WestConnex M4-M5 Link Modification 7

Modification to permanently close Northcote Street,
Haberfield
State Significant Infrastructure Modification Assessment
(SSI 7485 MOD 7)

Published by the NSW Department of Planning and Environment

Figure 3 | Indicative design of the pedestrian access (Source: Modification Report April 2022)

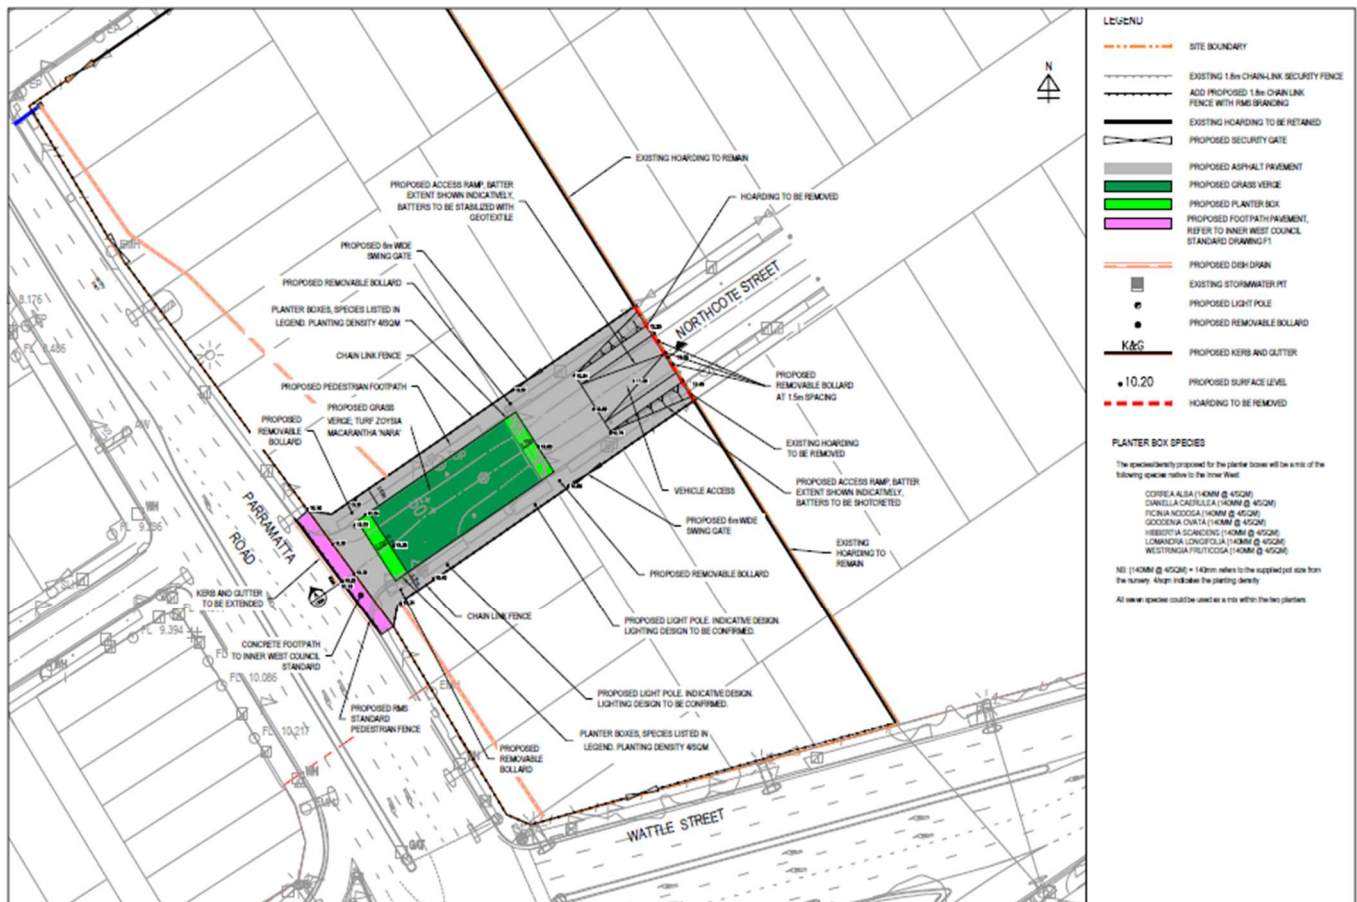
- request for a semi-circular design that allows for service vehicles like garbage trucks to turn around safely
- the proposed design of the pedestrian ramp and railing is unsafe for children as the design doesn't provide a continuous footpath and the full extent of the handrail
- the design is too minimalist, inadequate and is out of character with the 'Garden Suburb' identity of Haberfield, the permanent closure offers a rare opportunity to create greenspace on the Parramatta Road corridor and to establish the garden character of Haberfield
- a children's playground, street furniture and a drinking fountain should be provided.
- reduce the size of concrete area to standard pedestrian footpaths and cycleway to allow for more landscaping and greenspace
- request to provide privacy, improve safety, reduce noise levels by introducing a wall or raised garden beds and additional vegetation

Community submissions raised concern that the proposed permanent closure requires an appropriate cul-de-sac design with a turning circle, particularly for large vehicles and garbage trucks to safely manoeuvre around the closure point of Northcote Street. There was also concern for the 'minimalist' design that is out of character with the 'garden suburb' character of Haberfield and that the design demonstrated the potential for future traffic access on Northcote Street.

Community submissions referenced the importance of the provision of additional landscaped areas, and for trees to align with the established streetscape of Northcote Street. Submissions identified the opportunity to achieve greater amenity for the local area by providing additional green space, street furniture and play equipment. Submissions also raised concern for pedestrian safety with regard to motorists.

- semi-mature trees in standalone pots along with heritage features including brickwork and/or sandstone features on planter boxes and along walkways, and,
- extension of the footpath and the removal of handrails at the top of the pedestrian access ramp.

In response to community concern for pedestrian safety, an updated proposal was provided in the RtS which removes the proposed perpendicular handrails adjoining the top of the pedestrian access ramp (as shown in Figure 2). The footpaths are proposed to be extended for direct access between Northcote Street and the pedestrian connection.

Figure 4 | Surveyed intersections (Source: Modification Report April 2022)

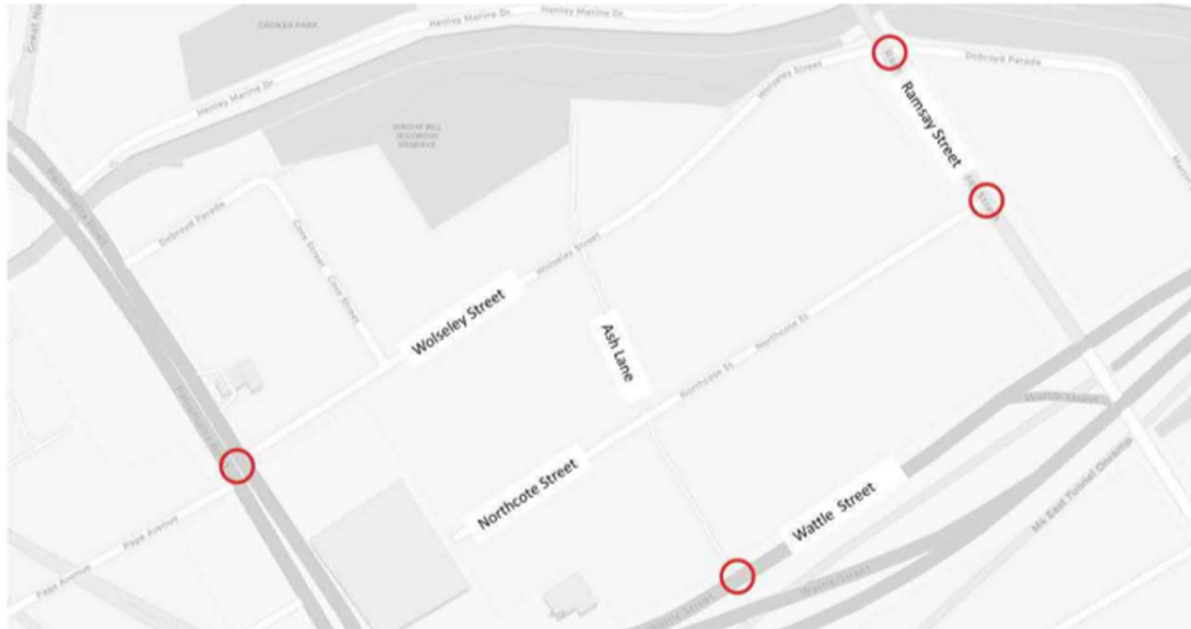
Inner West Council (Council) raised concern that the amenity impact of the permanent closure had not been adequately addressed in the traffic assessment, particularly for the residents of Wolseley Street. Council noted that the proposal is generally opposed by Wolseley Street residents and supported by Northcote Street residents with regard to through traffic impacts and safety concerns. Council requested for the Proponent to specifically address amenity concerns at Wolseley Street.

Community submissions on the proposed modification were concerned with increased traffic, the creation of a permanent 'rat-run' on Wolseley Street, reduced safety along Wolseley Street and loss of on-street parking.

The traffic impact assessment considered existing performance of intersections against long term operation impacts of a permanent closure at Northcote Street. All intersections were found to operate at acceptable levels of service (LoS) in all peak periods (AM and PM weekdays and Saturday peaks) and the modification it is not expected to result in adverse impacts on traffic capacity or road network performance, including Wolseley Street. The Department notes that Wolseley Street intersection at Parramatta Road is a left in left out that would limit the potential of 'rat-run' traffic due to the limited movements available.

The Department is satisfied that traffic volumes would remain satisfactory at key intersections as a result of the proposed modification. The traffic assessment is considered reasonable with regard to the proposed modification, with no changes to current local traffic network as a result of the permanent closure.
